Access Compliance Report

Public Rights-of-Way

(Curb Ramps)

Intersection ID: 16828	Main Street: BUCKNELL_AV	Cross Street: SELWYN_AV	Location: NE
ADA ID: 94806C461A87	Ramp Type: Perp	Initial Pass/Fail: Fail	Overall Compliance: No
Codes/Mitigation Info/Possible Solution		Field Measurements/Component Compliance	
Severity Score: 33.75

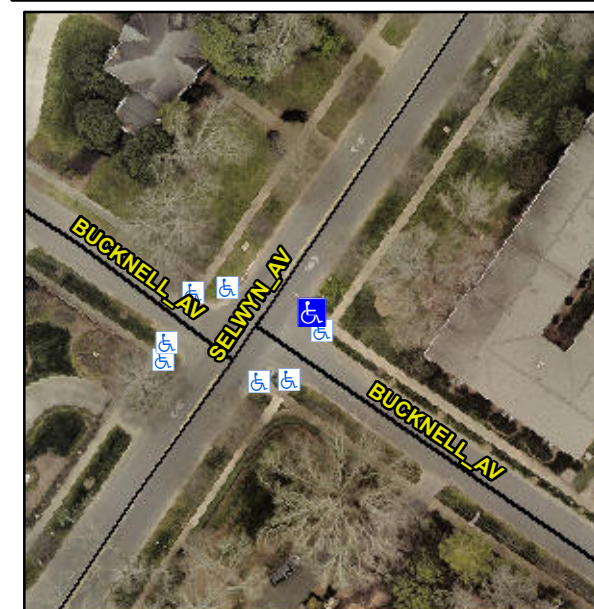
Not Found, R304.5.1, R304.2.2, R304.5.3

Compliance	Description	Data	Compliance	Description	Data
N/A	Ramp Length (in)	59.5	No	Ramp Slope (%)	9.2
No	Ramp Width (in)	43.0	No	Ramp XSlope (%)	5.5
N/A	Flare Type LT	N/A	N/A	Flare Type RT	N/A
N/A	Flare Slope LT (%)	N/A	N/A	Flare Slope RT (%)	N/A
N/A	Flare Traversable LT?	N/A	N/A	Flare Traversable RT?	N/A
N/A	Landing Length (in)	N/A	N/A	DWS Provided?	N/A
N/A	Landing Width (in)	N/A	N/A	DWS Contrast?	N/A
N/A	Landing Slope (%)	N/A	N/A	DWS Length (in)	N/A
N/A	Landing X Slope (%)	N/A	N/A	DWS Full Width?	N/A
N/A	Landing Curb? (Y/N)	N/A	N/A	DWS Offset (in)	N/A
N/A	Shared Landing?	N/A			
N/A	Gutter Ponding?	N/A	N/A	Gutter Slope (%)	N/A
N/A	Gutter Lip Ht (in)	N/A	N/A	Gutter X Slope (%)	N/A
N/A	Painted X Walk1?	No	N/A	Painted X Walk2?	N/A
	X Walk 1 Direction	To NW		X Walk 2 Direction	N/A
N/A	X Walk 1 Width (in)	N/A	N/A	X Walk 2 Width (in)	N/A
	X Walk 1 Slope (%)	5.3		X Walk 2 Slope (%)	N/A
	X Walk 1 X Slope (%)	2.3		X Walk 2 X Slope (%)	N/A

Remove & Replace Entire Ramp.
